Docket No. 50-336

Millstone Nuclear Power Station, Unit No. 2  
Proposed Revisions to Technical Specifications  
Steam Generator Inservice Inspection

March, 1983

FIGURE 2

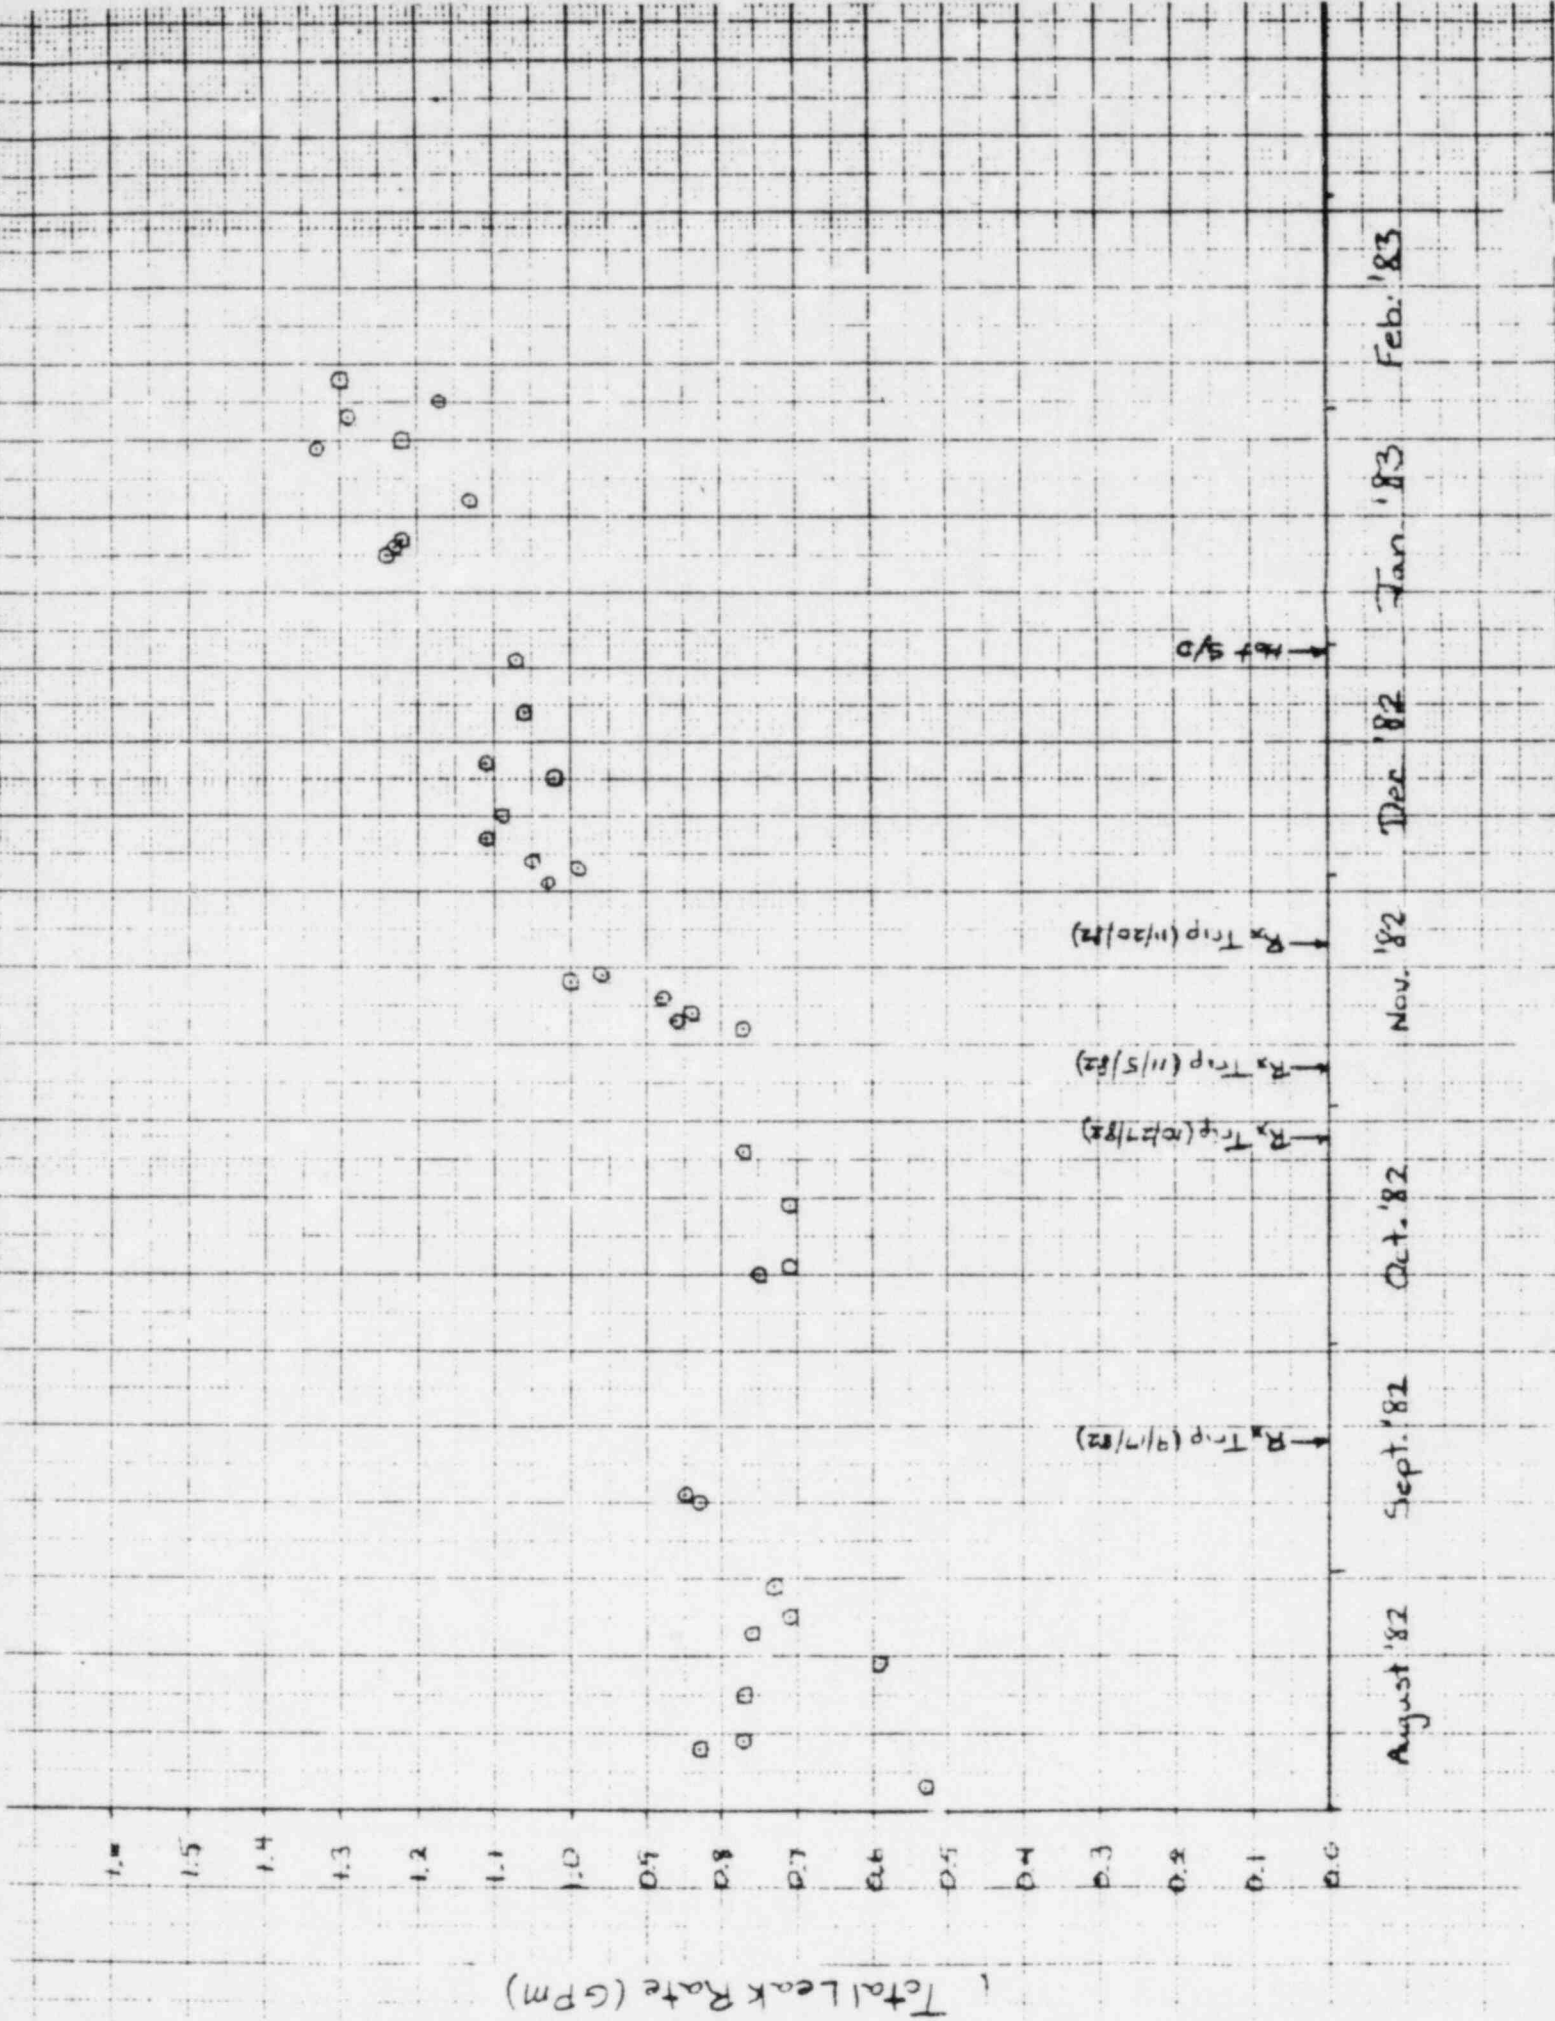
EDDY CURRENT INSPECTION  
PATTERN

STEAM GENERATOR IDENT **1(HL)**  
TUBE SHEET VIEWED FROM PRIMARY SIDE
